Monthly Specification Update

Intel[®] Server Board S5520UR

Intel Order Number E69054-001

March 2010

Figure 1. Removing the Heatsink

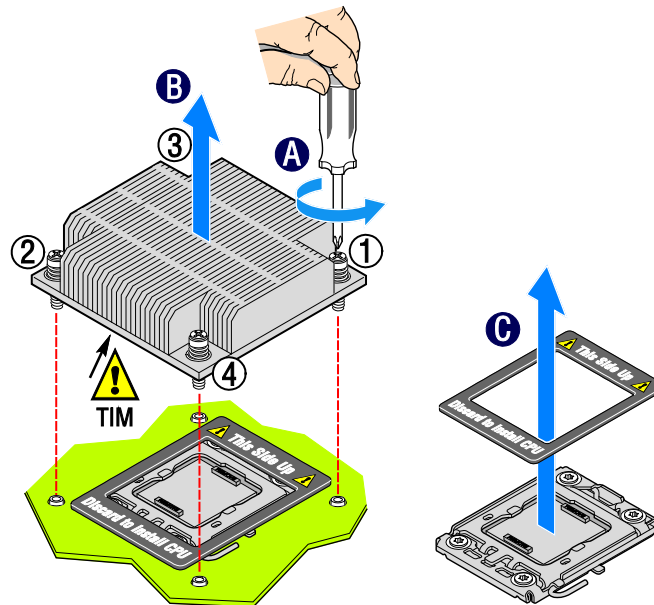
1. Proper Heatsink Installation and Removal Instructions are missing from Service Guide

Problem: The current documentation does not properly describe the installation and removal of the heatsink. Careful insertion and removal of the heatsink is required to prevent damage to the heatsink screws or backplate.

1. Loosen the four captive screws on the heatsink corners in a diagonal manner according to the numbers shown in figure 1 as follows:
 - Starting with the screw at location 1, loosen it by giving it **two rotations** in the anticlockwise direction and stop. (**IMPORTANT:** Do not fully loosen.)
 - Proceed to the screw at location 2 and loosen it by giving it two rotations and stop.
 - Loosen screws at locations 3 and 4 by giving each screw two rotations and then stop.
 - Repeat steps 1a through 1c by giving each screw two rotations each time until all screws are loosened.
2. Do one of the following:
 - If removing the heatsink for the first time, do the following:
 - i. Lift the heatsink from the board.
 - ii. Remove and discard the spacer (see letter “C” in figure 1).

- If a processor is already installed, do the following:
 - i. Twist the heatsink slightly to break the seal between the heatsink and the processor.
 - ii. Lift the heatsink from the processor. If it does not pull up easily, twist the heatsink again. Do not force the heatsink from the processor. Doing so could damage the processor.
